• 2014 DRC SUBMISSION – Proposed revisions to Tucson 2 project

LIST OF PROPOSED CHANGES

The Hub at Tucson II

CHANGES SUBMISSION. **PROPOSED**

1 2ND FLOOR PLAN
Scale: 1/8" = 1'-0"

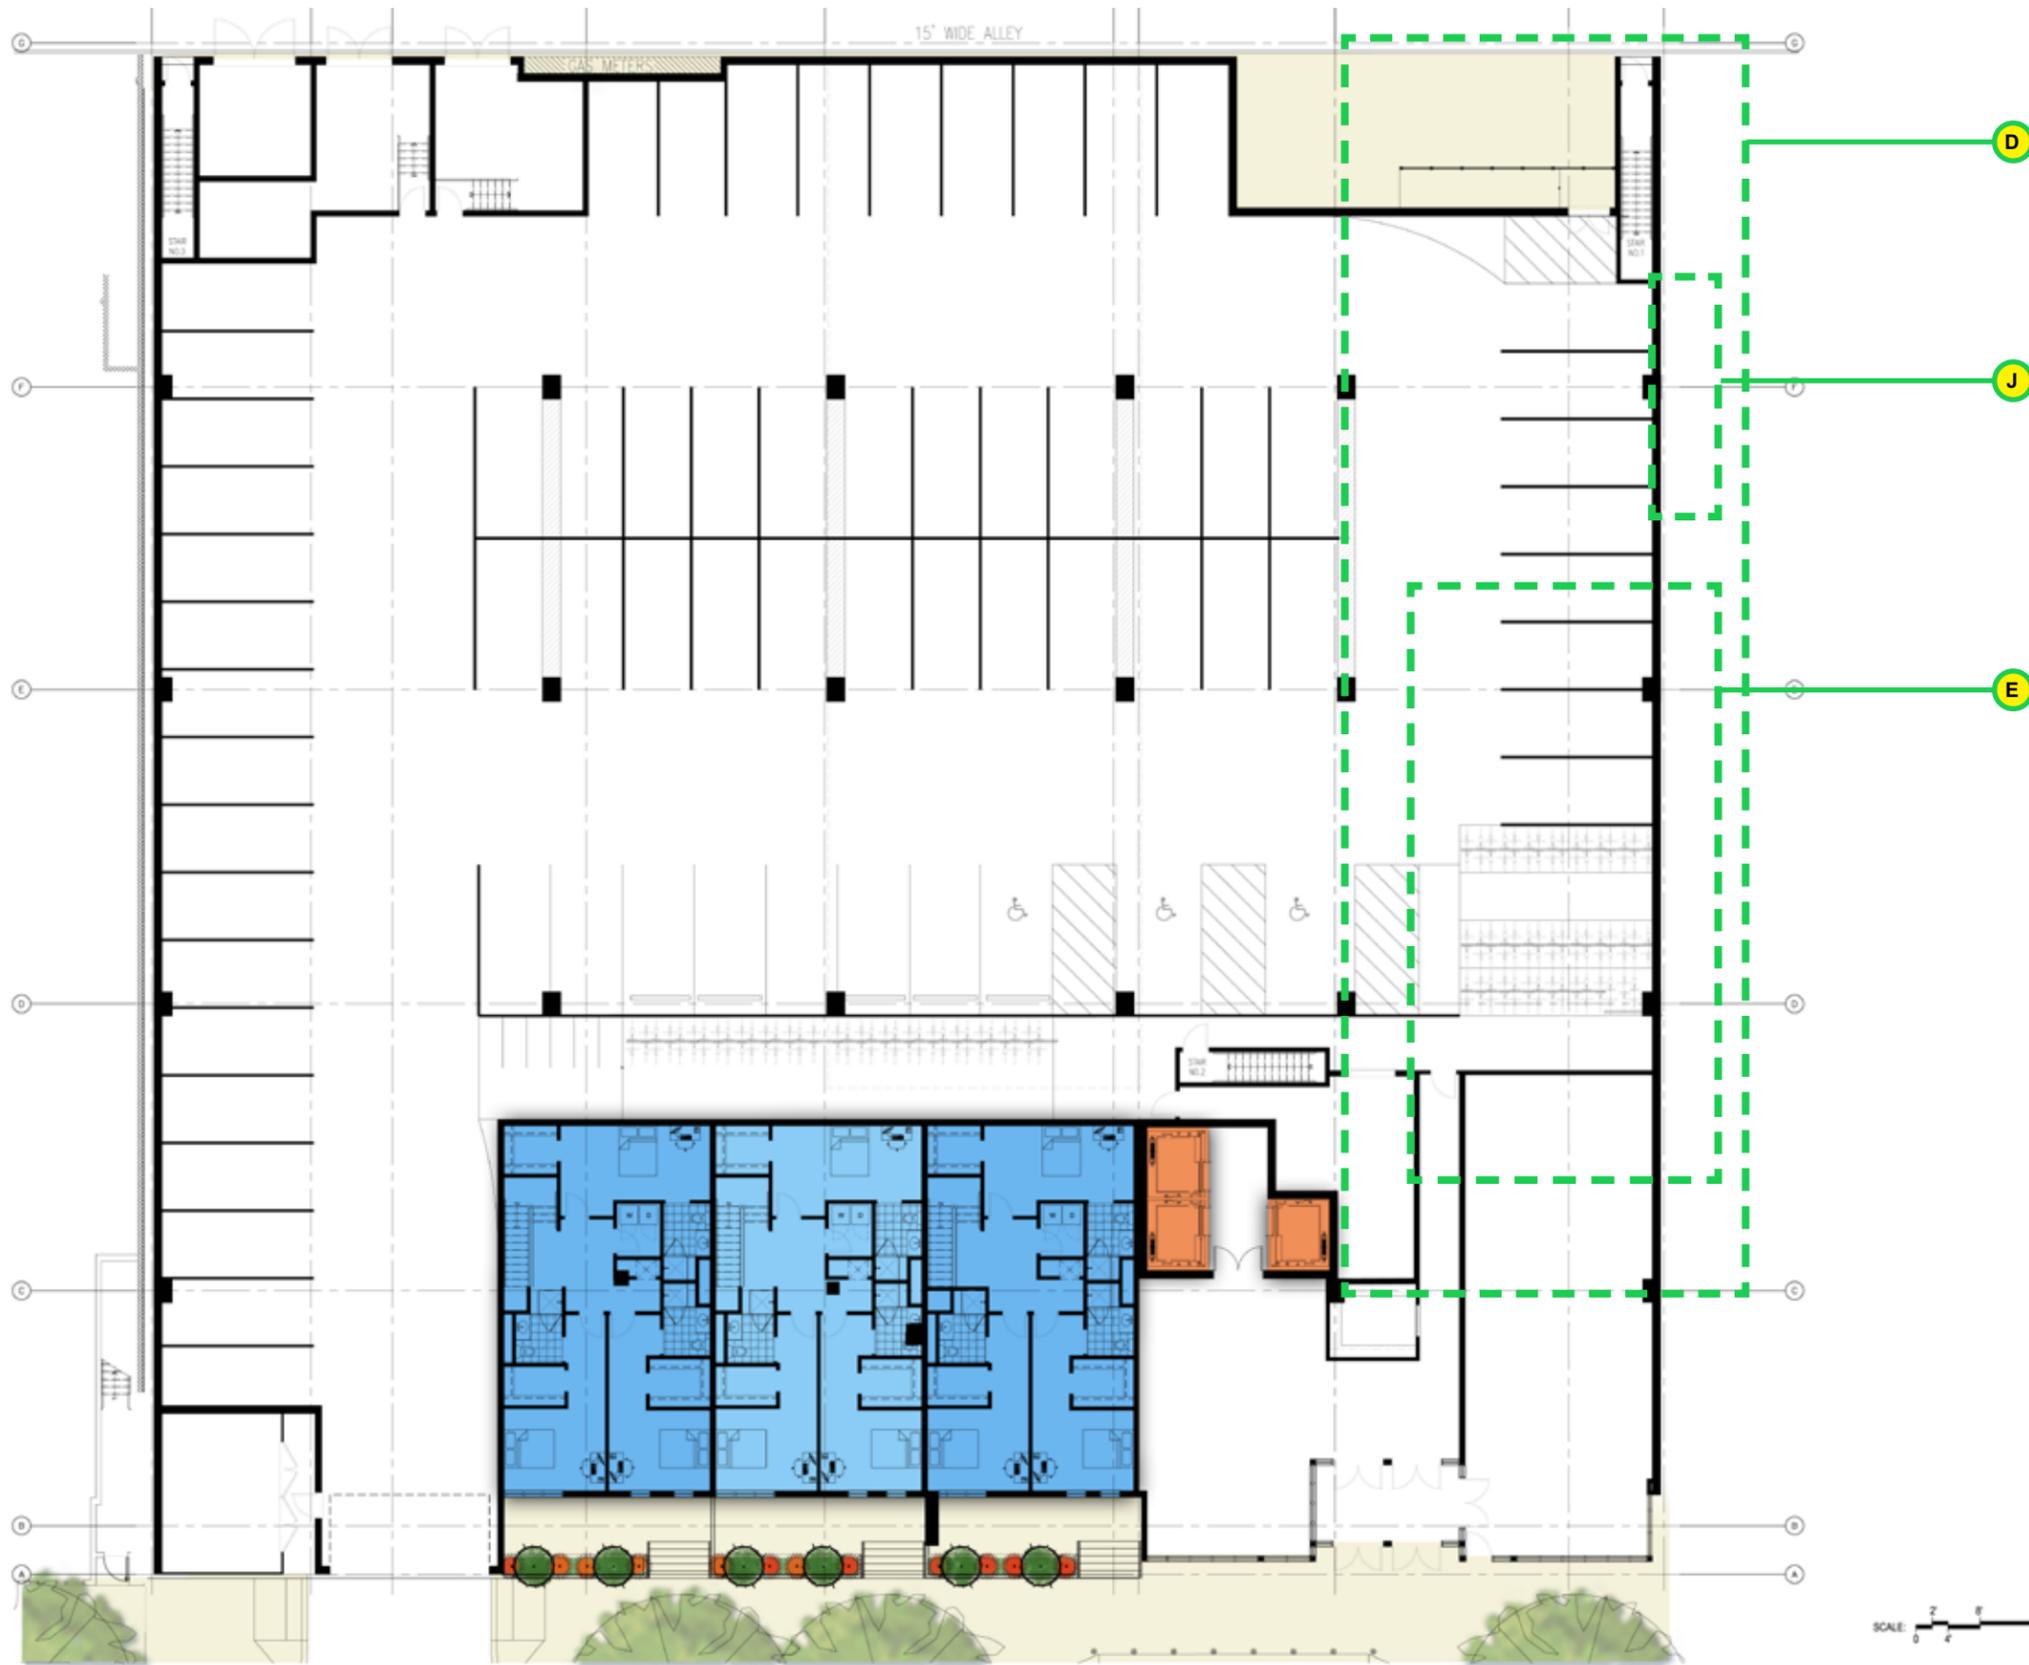
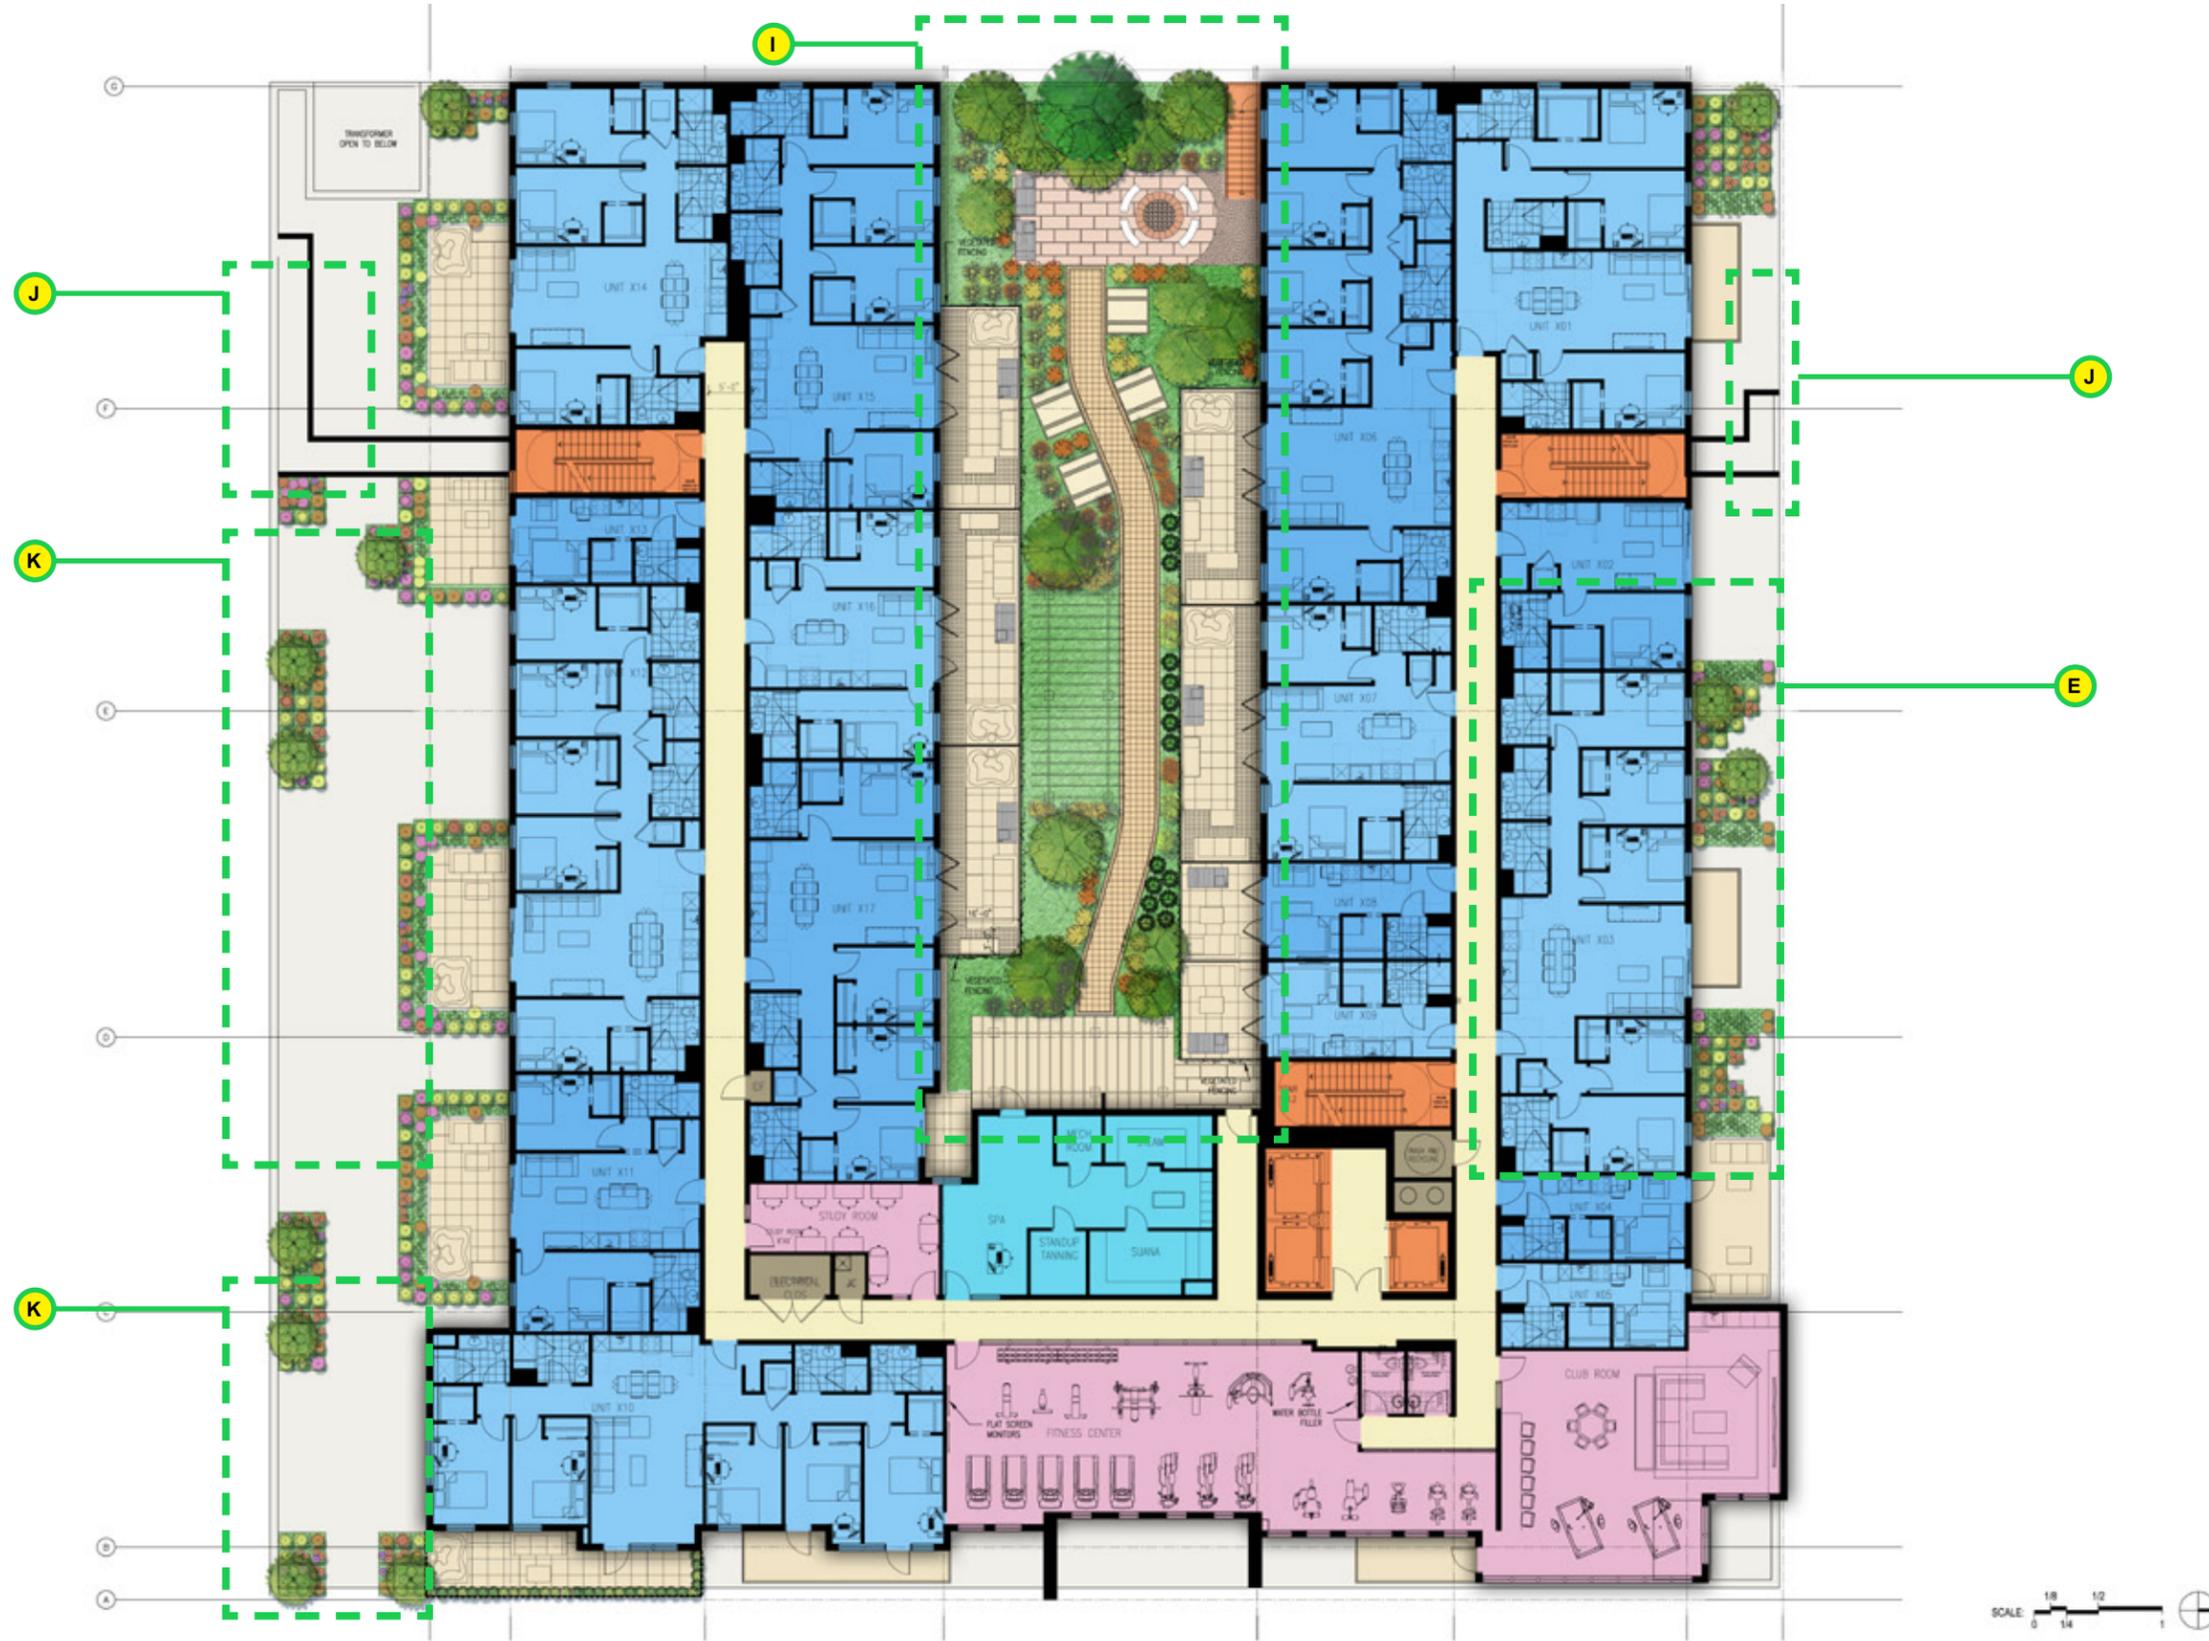
- **D** - Addition of mezzanine units to the north wing of the building.
- **E** - Duplex units added to center of north wing and balcony arrangement altered. Associated Balconies increase in width from 15' to 18'. Layout and extent of glazing on north façade changed from 3,006 sqf (Approved scheme) to 3,784sqf (Proposed scheme), resulting in 778 sqf of additional glazing.
- **F** - Rooftop terrace area reduced, pool and hot tub relocated to the courtyard. Rooftop terrace screen material changed from glass infill to metal panel infill. Extent of mechanical screen increased to location on the north wing. Landscaping altered to suit new layout.
- **L** - All balconies reduced from 6' to 5' deep, excluding balconies on Tyndall street.
- **Q** - Number of balconies reduced on the north and south elevations from 26 to 16.

PERCENTAGE OF FIRST FLOOR TO MEZZANINE AREA	
TOTAL GFA OF FIRST FLOOR	35,737 sqf
TOTAL GFA OF MEZZANINE	7,900 sqf
TOTAL GFA PERCENTAGE	22%

PROPOSED POOL AREA COMPARED TO APPROVED	
APPROVED POOL AREA	828 sqf
PROPOSED POOL AREA	440 sqf
POOL AREA REDUCED BY 388sqf
